## **Service Notification**

Level Sensor 200--00093

## IMPORTANT SAFETY RECALL NOTICE NHTSA RECALL 15E-084

November 20, 2015

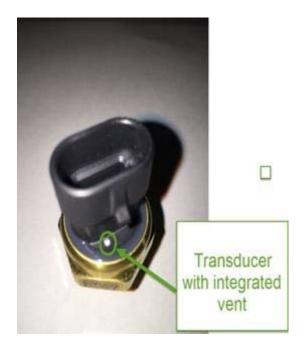
The issue was addressed in production and the vent to atmosphere has been repositioned to the outside of the transducer housing (see figure 1) for all transducers shipped after July 30, 2015.

You may receive a reconditioned part as shown in figure 2 whereby a small vent hole has been drilled through the connector housing and a hydrophobic seal has been placed over the vent hole to prevent moisture intrusion. For applications where a replacement transducer has been installed with a hydrophobic seal, Hale Products, Inc. will extend the transducer warranty period from two years to three years from purchase date.
